MENDOCINO HISTORICAL REVIEW BOARD STAFF REPORT

JULY 1, 2019
MHRB_2016-0018

PROJECT DESCRIPTION: A Mendocino Historical Review Board Permit request to demolish, reconstruct, and/or construct the Ferro House, garage, tower, fencing, driveway and other structures. Note: Mendocino Town Plan Appendix 1 lists the site as a Category IIa Historic Resource.

STREET ADDRESS: 45270 Albion Street, Mendocino (APN: 119-217-06)

**TOWER SOUTH & WEST ELEVATIONS -
EXISTING & PROPOSED**

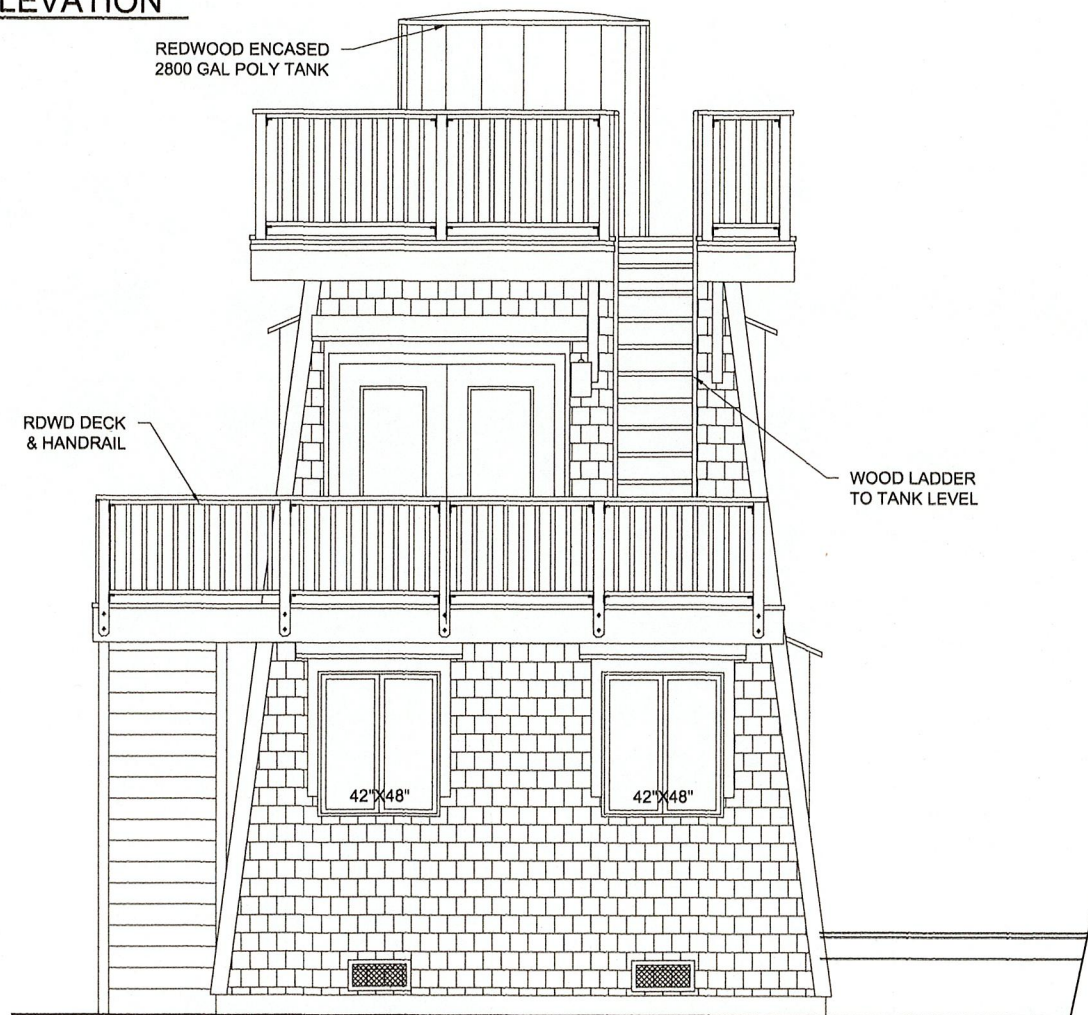
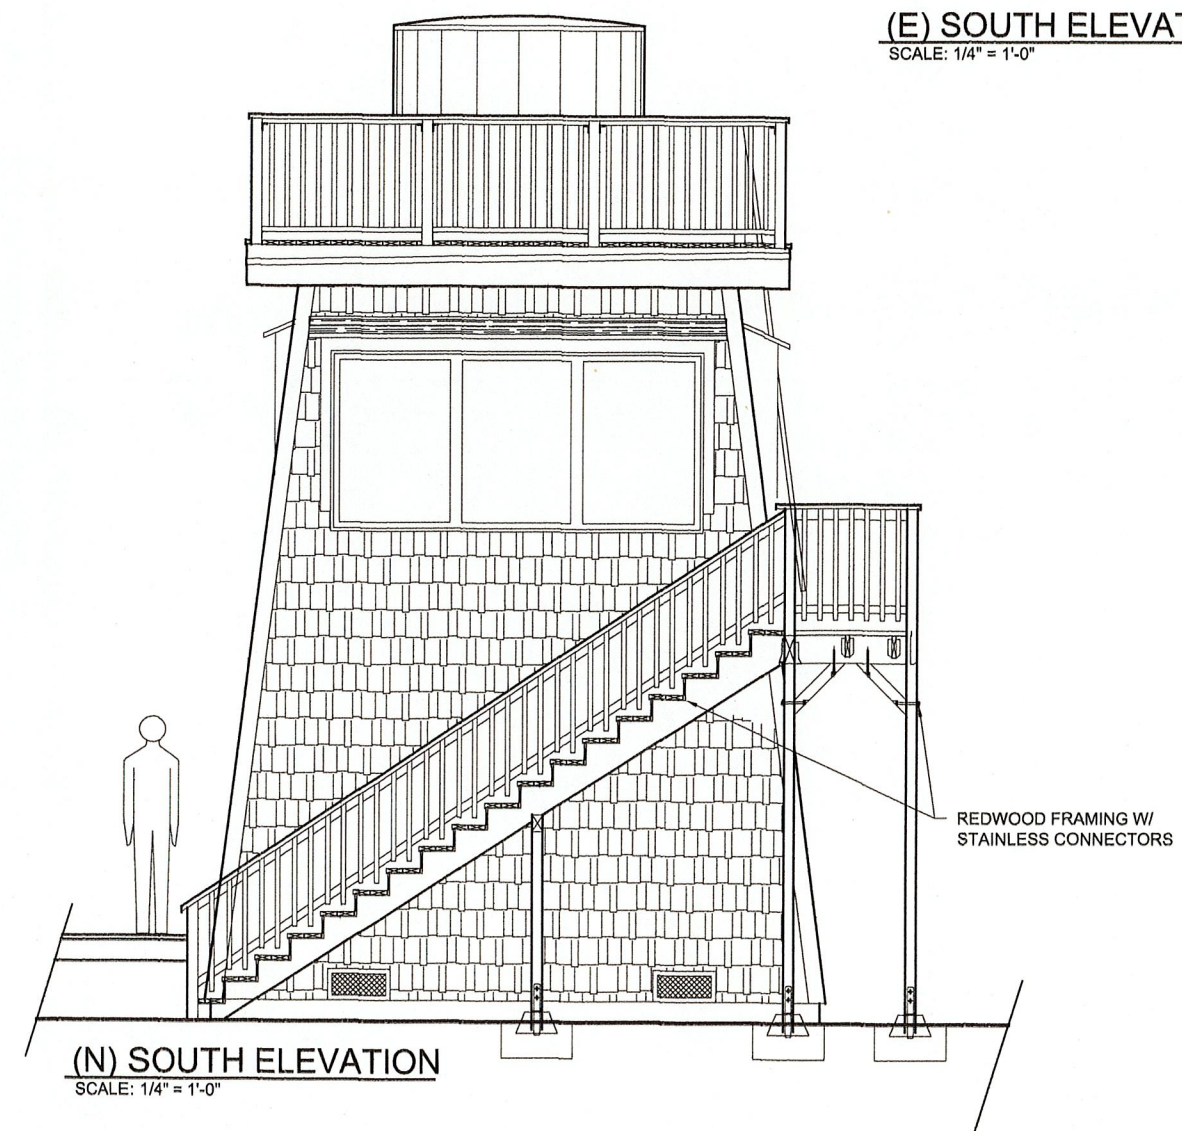
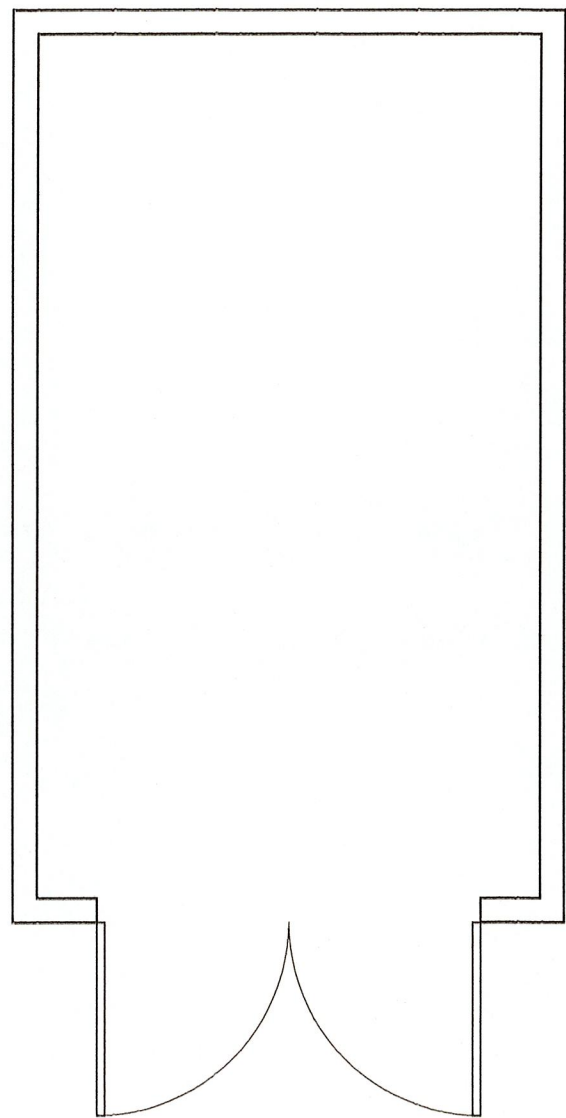
Existing Tower. The circa 1900 water tower is 14 feet in height and irregularly shaped (See Sheet No.'s A6 and A7 Tower Elevations). It has a footprint of approximately 200 square feet and has three entrances, two on the primary level, and one on the second level, with both interior and exterior stair cases to the second level. The overall condition of the tower is poor (CHRC 2016).

Proposed Tower. The applicant proposes to demolish the existing tower and to construct a new tower rebuilt in the same location but with a larger footprint (See Site Plan and illustrative elevation drawing).

As an accessory structure, the proposed 28 foot tall tower footprint would be 290 square feet. The siding on the tower would be cedar and the trim would be painted forest green. The tower would have an exterior door on each level with an external staircase projecting from the building footprint. A new 2,800-gallon water storage tank would be located atop the tower. The proposed water storage tank exterior would be lined with redwood slats and enclosed with metal bands. The proposed tower would be 28 feet in height above grade including the additional height of the water storage tank.

(E) & (N) GARAGE PLAN
SCALE: 1/4" = 1'-0"

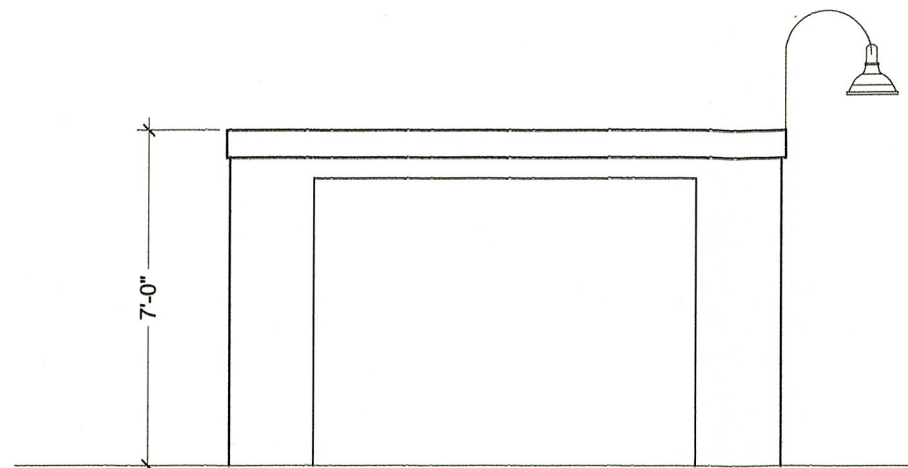
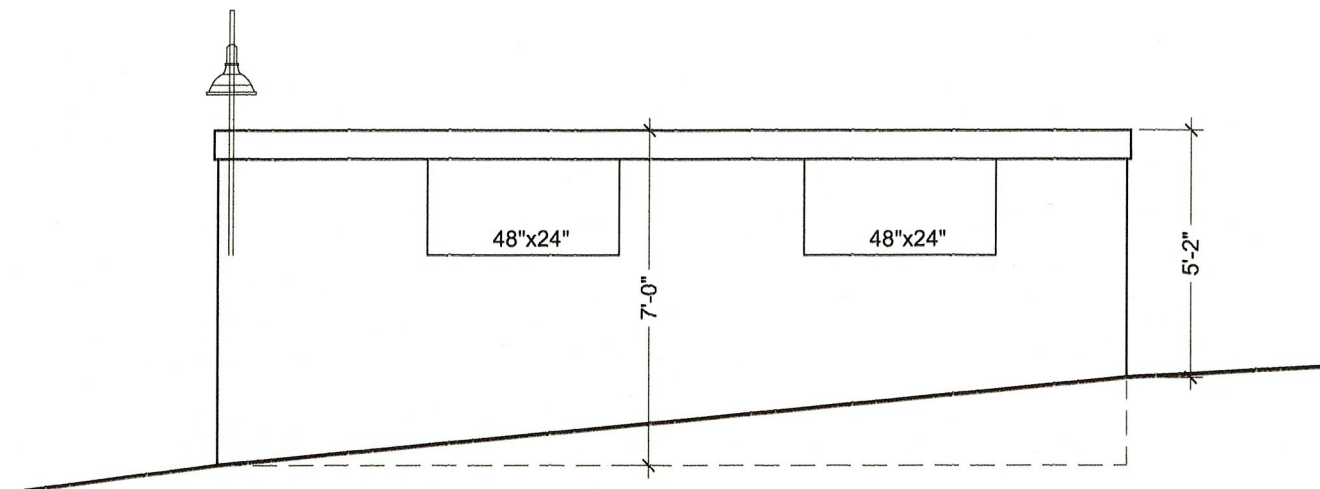
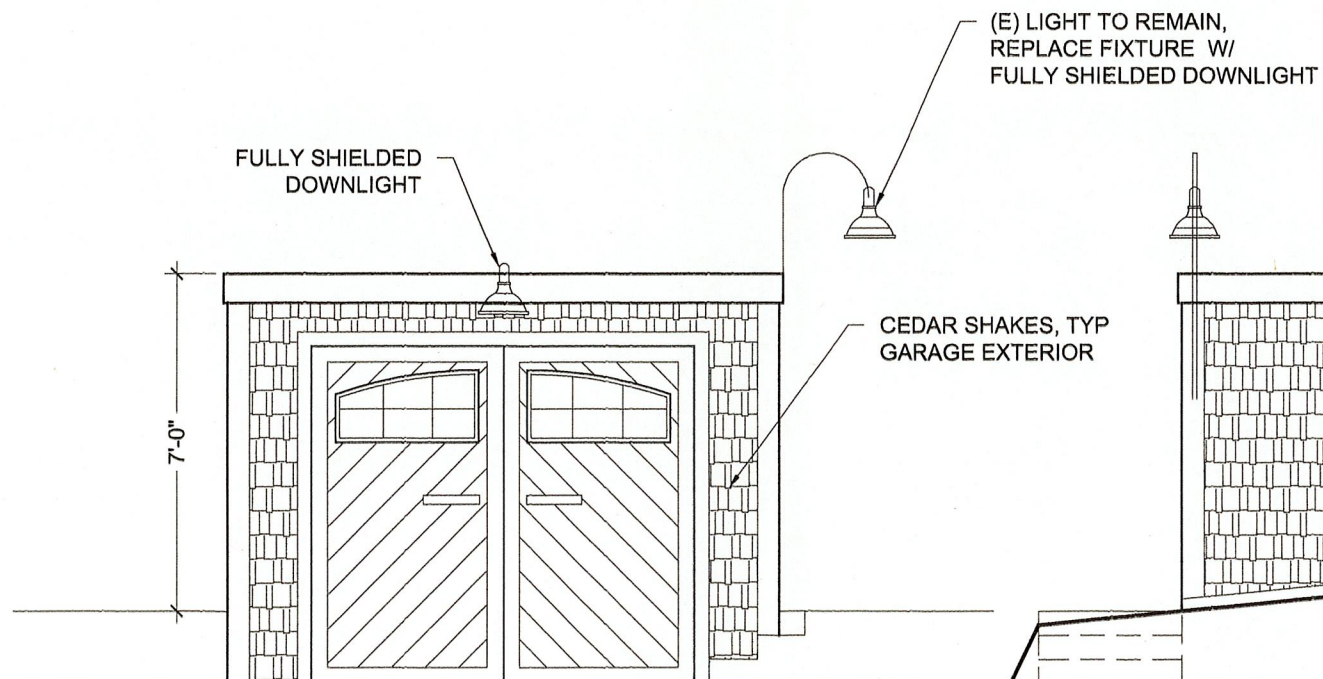
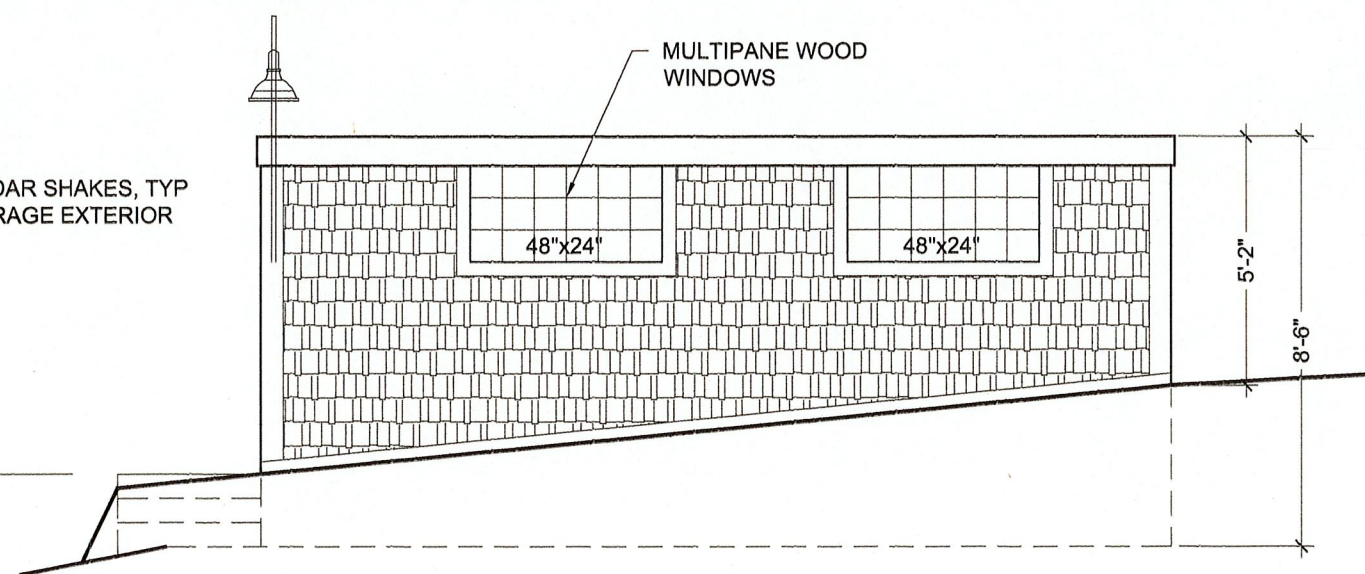
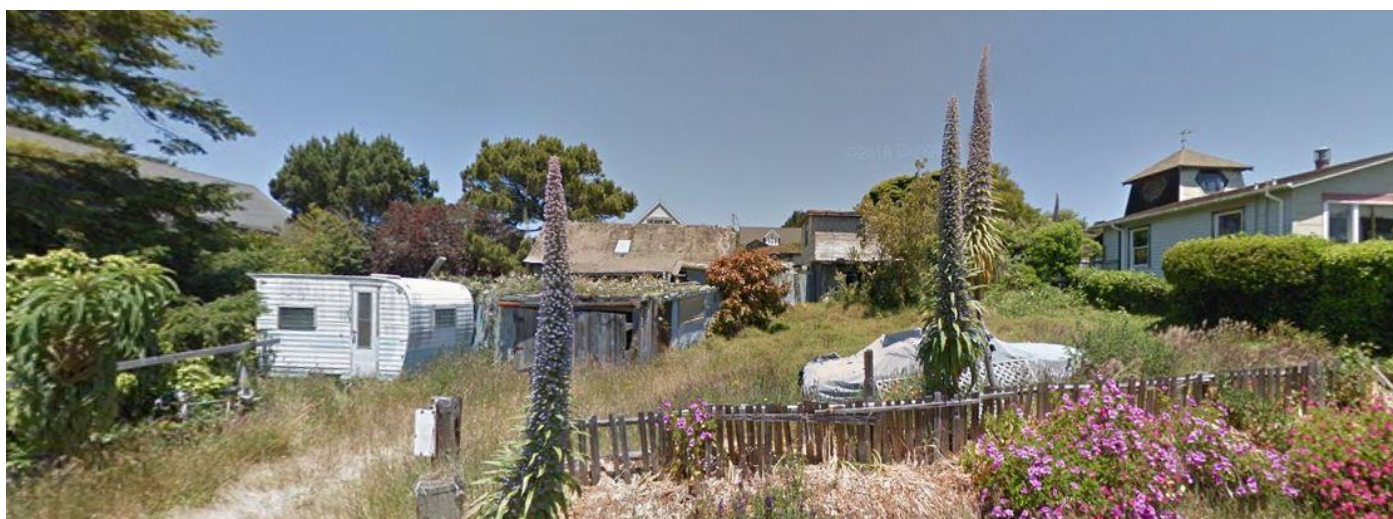
Existing Garage. The garage is approximately 12 feet by 20 feet and is built with a mixture of 2 inch by 12 inch wood boards, plywood, and corrugated metal siding (See Sheet No. A8 Garage Elevations and Floorplan). The south elevation is 7 feet tall; the north wall varies between 5.3 feet and 5.6 feet tall. It has a flat, sheet-metal roof covered in tar. The garage stands on a post foundation and has a dirt floor. A large, now defunct concrete lined well has been dug into the center of the floor. Wooden framework around the well has rotted extensively and has exposed tunneling below the floor. The garage door is composed of vertical 2 inch by 12 inch on-gate hinges. A rectangular window opening on the east wall has been covered by corrugated fiberglass paneling. The overall condition of the garage is poor (CHRC 2016).

Proposed Garage Restoration. The siding on the garage would be cedar shingles with redwood trim painted forest green (See Sheet No. A8 Garage Elevations and Floorplan). The flat roof of the garage would be rebuilt to the same shape and style. The floor of the garage would have the pit and tunneling removed and then covered with a cement slab. Windows on the garage would be replaced with multipane wood windows as shown on the elevations.

11. To the satisfaction of the Director of Planning and Building Services, exterior garage building plans shall provide sufficient detail for the successful reconstruction of the garage with a flat roofline.

Proposed Shingles on Exterior of Structures

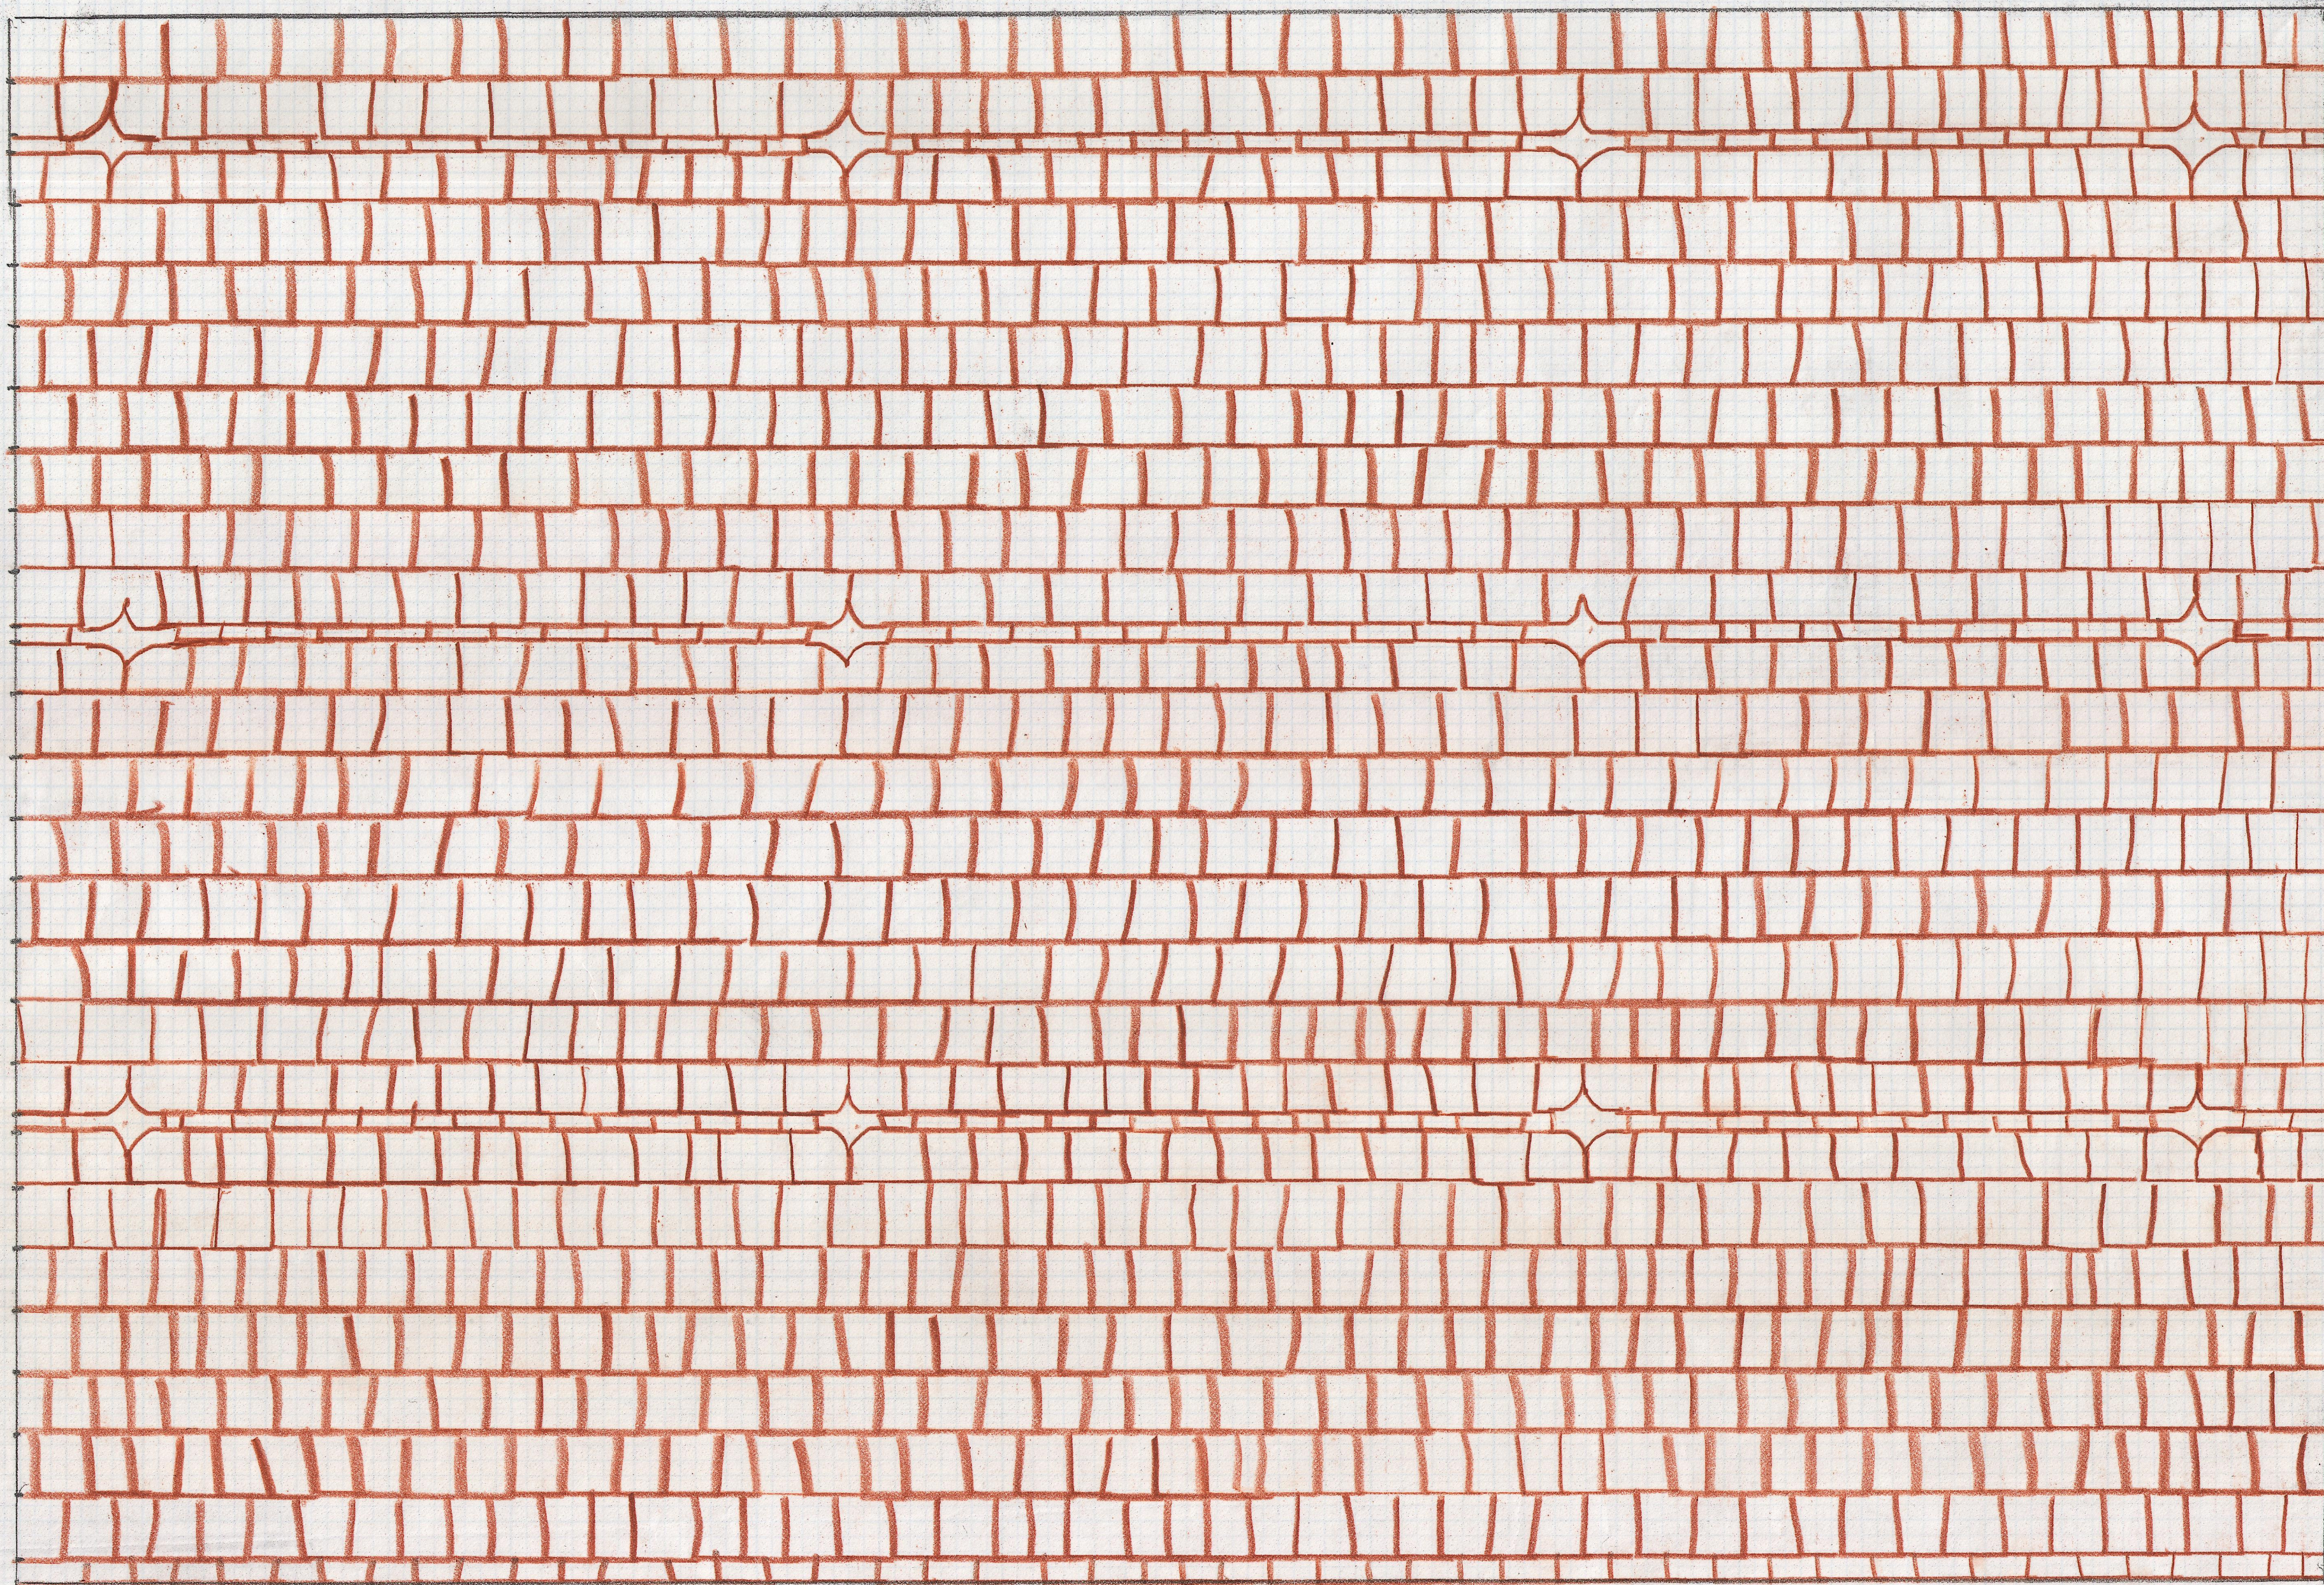
Attached to this memorandum as Attachment A is the shingle design that the applicant wishes to have approved for the exterior of the proposed structures under this application. Attachment A was part of the August 14, 2018 Staff Report for the project.
